ENCLOSURE 2

MFN 03-064

Response to NRC RAI numbers (187, 190, 191, 195, 202, 220,
225, 231, 232, 272, 296, 297, 327, 334–338, 345, 347, 349-
359, 371-376, 378, and 379)

Enclosure 2 RAIs NEDC-33079P “ESBWR Test and Analysis Program Description”

Figure 187A GDCS Equalization Line

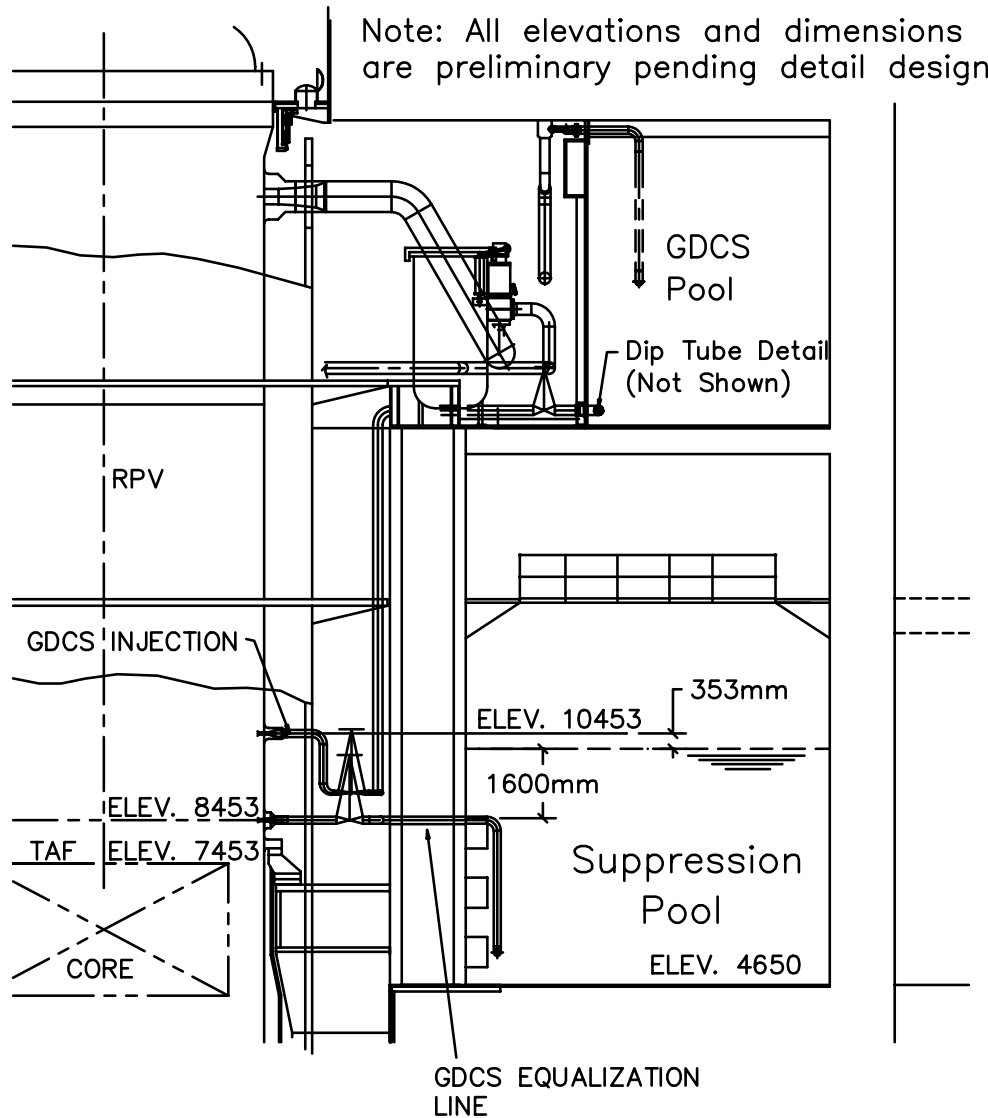
Q187. Page 2-5, Section 2.2.1.2 - For the last paragraph an elevation diagram would be helpful to the discussion.

- Q190. Page 2-9 (last paragraph) - It is stated that water collected in the drywell can spill into the wetwell through the spillover holes in the pipes connected to the horizontal vents. Please provide a sketch to show the elevation and diameter of the spillover holes and explain why their presence will not adversely affect horizontal vent clearing in a loss of coolant accident (LOCA).

R187. Please see Figure 187A and Figure 187B for details.

- R190. Please see Figure 187B (above) for details of the spillover holes. The holes lead from the annular region of the drywell (region surrounding the RPV) to the vertical vents, which lead to the horizontal vents under the water surface of the suppression pool. The spillover holes are 200 mm in diameter and are located about 550 mm above the normal level of the suppression pool water. One hole leads into each of the ten vertical vent pipes. The spillover holes provide a return path for water, which may accumulate in the lower drywell and the annular region of the drywell during a pipe break accident. The purpose of the spillover holes is to provide a means to limit the draw-down of the suppression pool water and thereby assure the PCCS heat exchanger vent submergence. Since the spillover holes are located above the normal water level in the vertical vents they have no impact upon the vent clearing process. The drywell atmosphere pressurizes the vertical vent water column and forces this level down to the first, second and sometimes even third horizontal vents in order to clear the vents and relieve the pressure differential.

Figure 202A ESBWR RPV

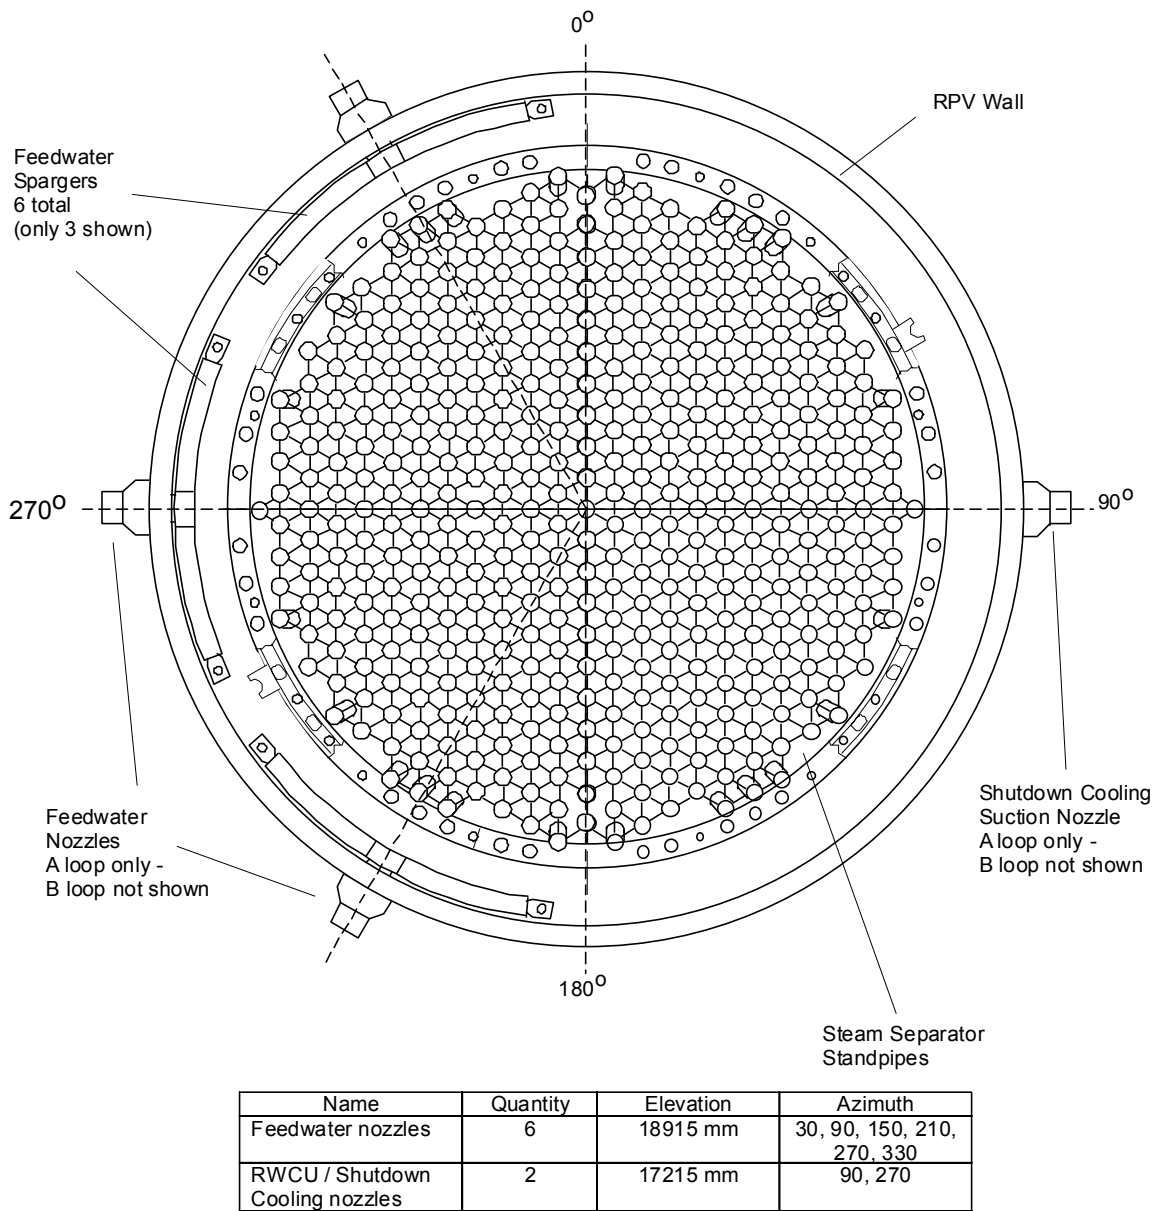
Q202. Page 3-27 (No.2 - B11/4) - It seems that the suction lines of the Reactor Water Cleanup/Shutdown Cooling (SDC) System are connected either to the RPV downcomer annulus or to the RPV bottom head and the injection lines are connected to the RPV via the main feedwater lines. (1) Please provide a sketch to show “inlet and outlet nozzles located diametrically across the downcomer.” (2) There is a typographical error in the fourth column, “CFD code calculations show sort [sic] circuiting will not occur” should be replaced with CFD code calculations show short circuiting will not occur.

R202. Please refer to Figures 202A and 202B for details of the shutdown cooling suction nozzle and the feedwater nozzles.

The typographical error will be corrected in the report, NEDC-33079P “ESBWR Test and Analysis Program Description” and will specify: “CFD code calculations show short circuiting will not occur.”

Figure 353.1. RPV Collapsed Level in Test P1/8

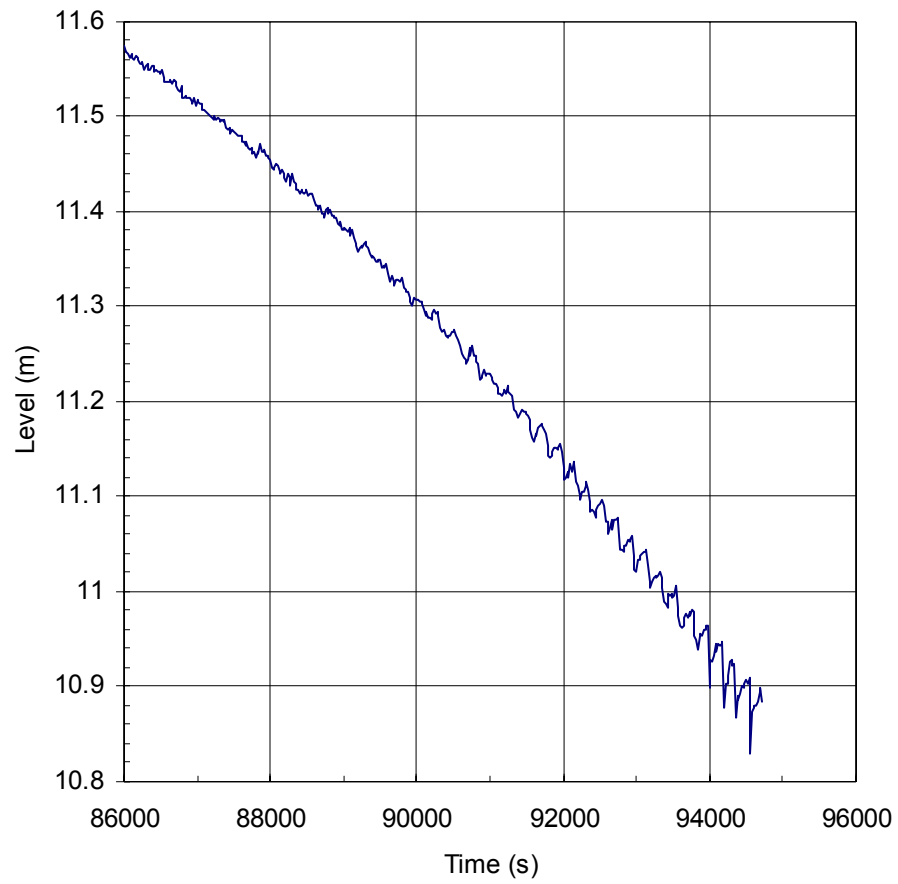
Q353. ALPHA-716-0/Page 20 (Fig. 5). [[

R353. [[

Figure 359.1. Main Vent 1 Instrument Locations

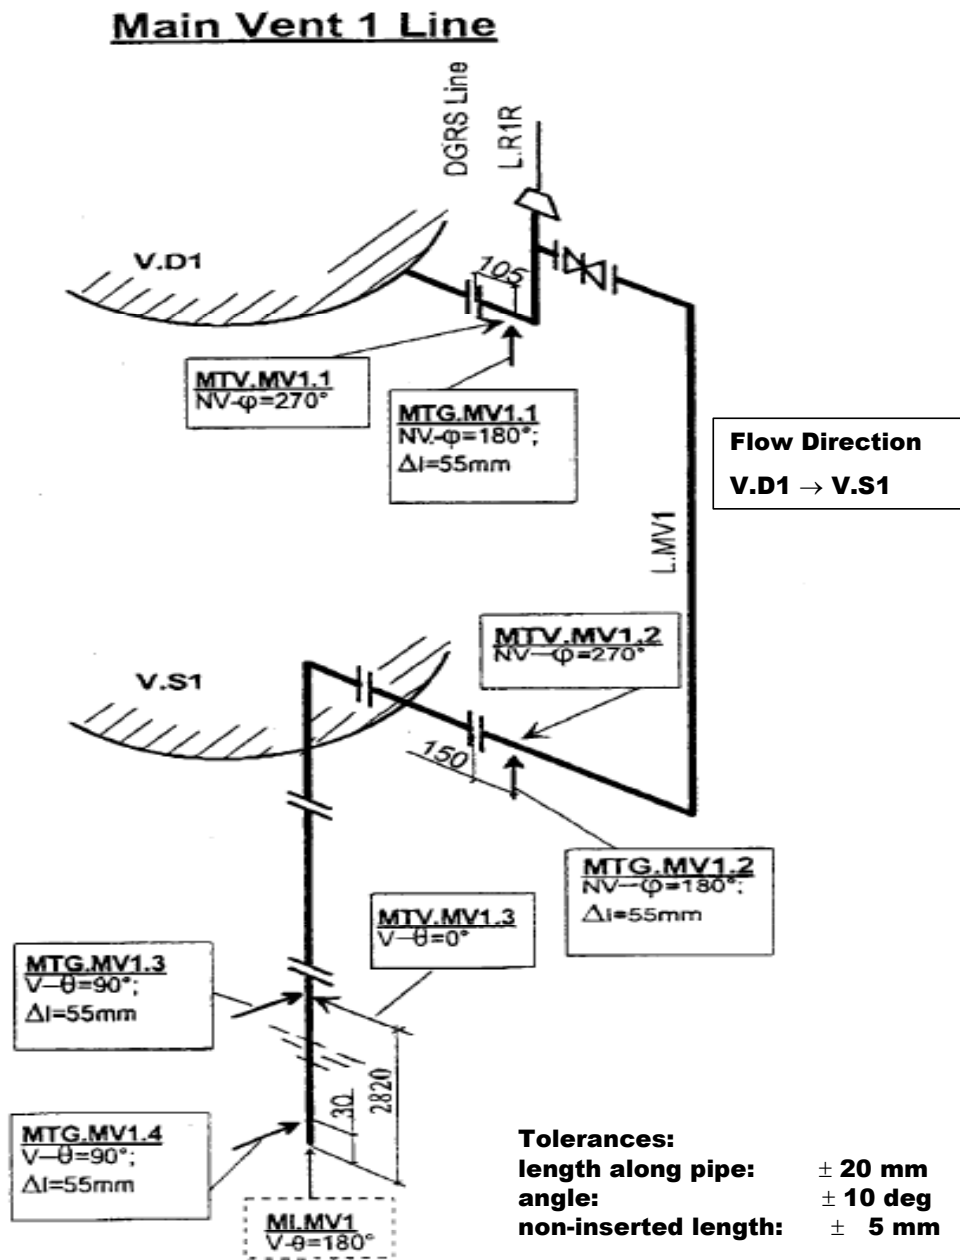
Q359.1. Please provide an instrumentation diagram to show where these main vent thermocouples were located.

R359.1. The main vent instrument locations are shown in Figures 359.1 and 359.2. The thermocouples used to measure gas temperatures are identified as MTG.MV1.1 - 4 and MTG.MV2.1 - 4. Dimensions are in millimeters.
